From: Martinez, Javier, NMDOT <Javier.Martinez@dot.nm.gov>
Sent: Tuesday, October 25, 2022 3:01 PM
To: Carl Vermillion
Cc: Glenn Broughton; Bert Thomas
Subject: RE: [EXTERNAL] New Solar Site STA

Site Threshold Analysis (STA)

TO: Javier Martinez, PE, NMDOT District 5 Assistant District Engineer
FROM: Carl Vermillion
DATE: October 5, 2022
SUBJECT: AES Rancho Viejo Solar Development – Traffic Assessment

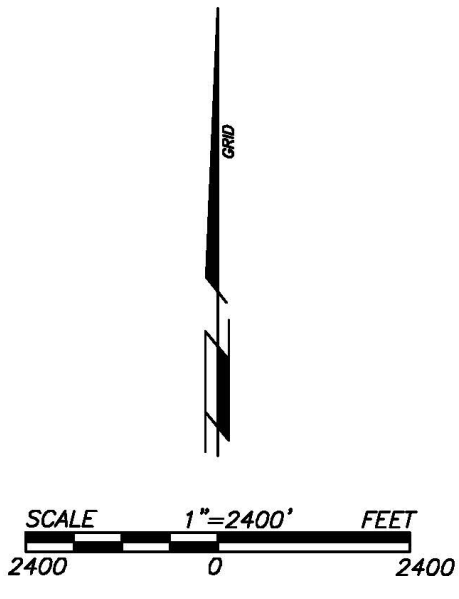
An existing access point for the property has a gated entry on NM 14 1,300 feet to the north of the existing Turquoise Trail Charter School. This entry serves the development property today, but the development wants to improve and realign this access point to facilitate traffic for the construction of the solar farm. As part of this realignment, the access point will be moved to the north approximately 450 feet to align with the existing on site travel pattern. This new location will be located approximately 100 feet to the north of the existing driveway on the west side of NM 14. It is understood that this will require a new driveway permit with the NMDOT and this process will begin soon after this STH process is discussed and approved.

Additionally, a driveway permit will be required to move the access point to the north by 350 feet. Should future development activities propagate additional traffic evaluations, these will be conducted to assess those project-specific needs and traffic generation.

Good Afternoon,
NMDOT will accept the form as submitted and the applicant will need to apply for an access permit.
Thank you,
